RECEIPT DATE: 6/17/2021 **ONSITE SEWAGE DISPOSAL SYSTEM** P 569569
APPROVAL DATE: 12/15/21 (ST) **PERMIT: CONSTRUCTION** A _____
PROPERTY ADDRESS: 11600 JOHNS HOPKINS ROAD, CLARKSVILLE, MD 21029
SUBDIVISION: A J GILL PROPERTY LOT: 1 TAX ID: 05-603234
CONTRACTOR: FOGEL'S SEPTIC CLEAN EMAIL: John @foglesinc.com
CONTRACTOR ADDRESS: 580 OBRECHT ROAD, SYKESVILLE, MD 21784 PHONE: (410)795-5670

MEMORANDUM

RE: BAT Site Plan
AJ Gill Property
11610 Johns Hopkins Road

Re: **AJ Gill Property
OSDS Permit Plan**

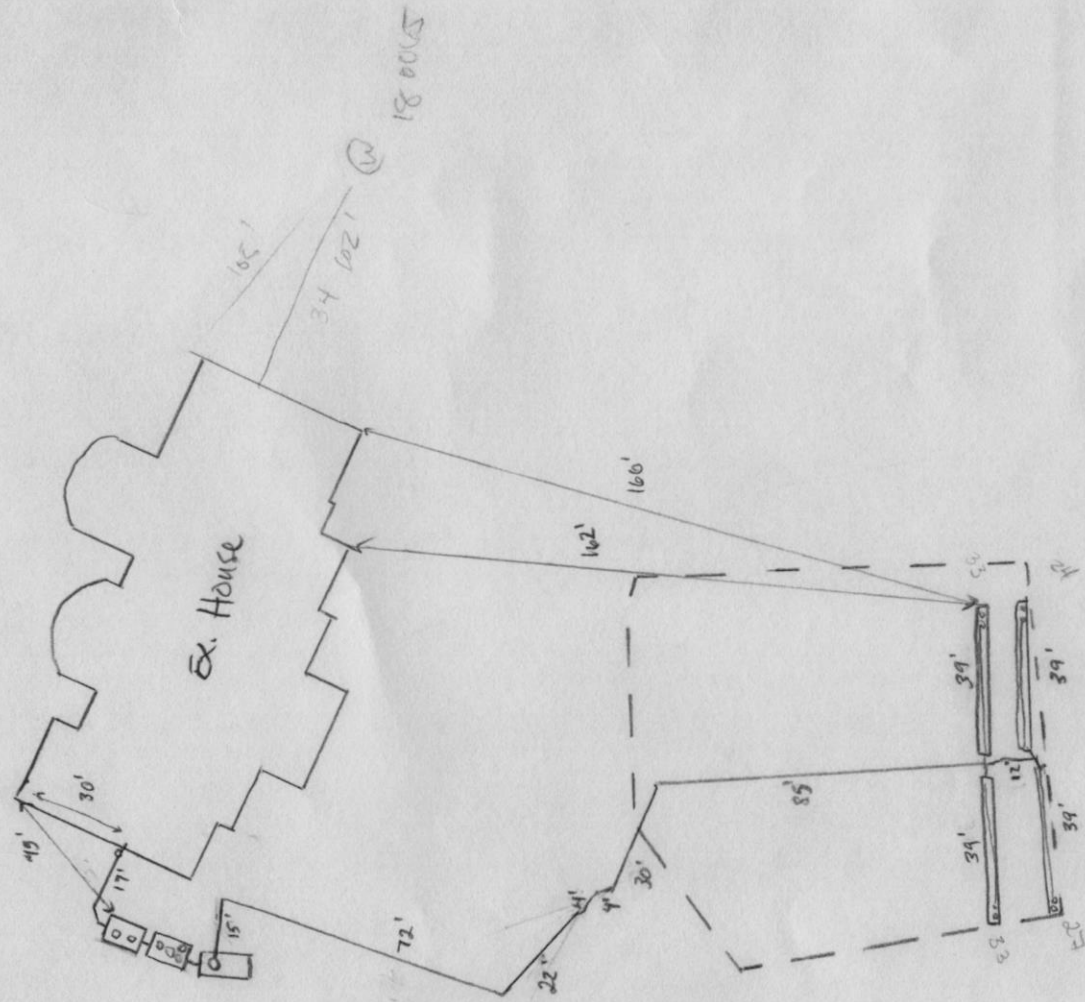
8/5/21 Fill on SDA and tanks location. Must be removed prior to layout. (SD)

8/25/21 Tanks set and SHC, SL and FM constructed. 4x39' trenches with laterals with 5 perforations 7'10" apart installed, confirmed by contractor. (SD) 12/09/2021 Sub. box OUTSIDE; DHR ENSCRIBED ON ASBUILT. TURN UPS NEED PROTECTIVE SLEEVE (D)

12/15/21 4" PVC sleeves on turn ups. (SD)
